Re: FortisBC Energy Inc. (FEI)
2022 Long Term Gas Resource Plan (LTGRP) ~ Project No. 1599324
Response to the BC Solar and Storage Industries Association (BCSSIA)
Information Request (IR) No. 3 on Rebuttal Evidence

FortisBC Energy Inc. (FEI or the Company) 2022 Long Term Gas Resource Plan (LTGRP) (Application)	Submission Date: October 13, 2023
Response to BC Solar and Storage Industries Association (BCSSIA) Information Request (IR) No. 3 on Rebuttal Evidence	Page 1

Transmission Network- RGSD Strengthens Entire System

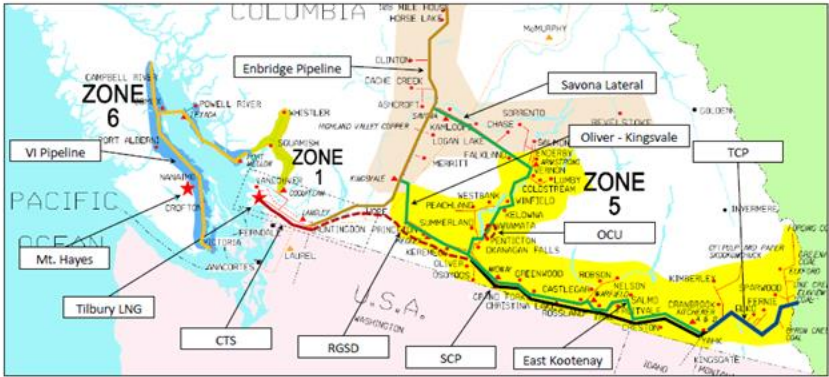
5 The map below roughly depicts FEI’s pipeline system, including the proposed RGSD
 6 project (map from Exhibit B-11, pdf page 393 of 453):

FEI’s Vancouver Island system appears to have the highest percentage of PE pipe (98%) but also the highest maximum pressure (2,160 psi). Does that make Vancouver Island a better or a worse prospect for hydrogen blending?

21.1.1 Even if there is a very low overall percentage of steel pipe in the system (such as 2% on Vancouver Island), is that not still a significant risk, since the total system can only be as strong as its weakest link? What measures would FEI use to protect that most susceptible 2% of the system?

For clarity, the Vancouver Island Transmission System has a maximum operating pressure of 2,160 psig and is comprised of steel pipe only, as noted in the preamble to the IR above. The Vancouver Island distribution systems operates at the significantly lower pressure of 80 psig and

1 is comprised of a mix of mainly polyethylene (PE) pipe and a small portion (2 percent) steel pipe
2 as clarified in the table in the preamble. The higher percentage of PE pipe on Vancouver Island
3 may provide an advantage for hydrogen blending feasibility compared to a distribution network
4 that would have more steel pipe, particularly if the portion of steel pipe in a network is older.
5 Regardless of the location of hydrogen injection, an assessment will be required on all assets that
6 would be affected by the proposed injection to satisfy operational and safety considerations prior
7 to hydrogen blending. However, given that the distribution system operates at low operating
8 pressures and low stress levels, the small percentage of steel pipe does not represent a significant
9 risk for hydrogen blending in the Vancouver Island gas distribution system.
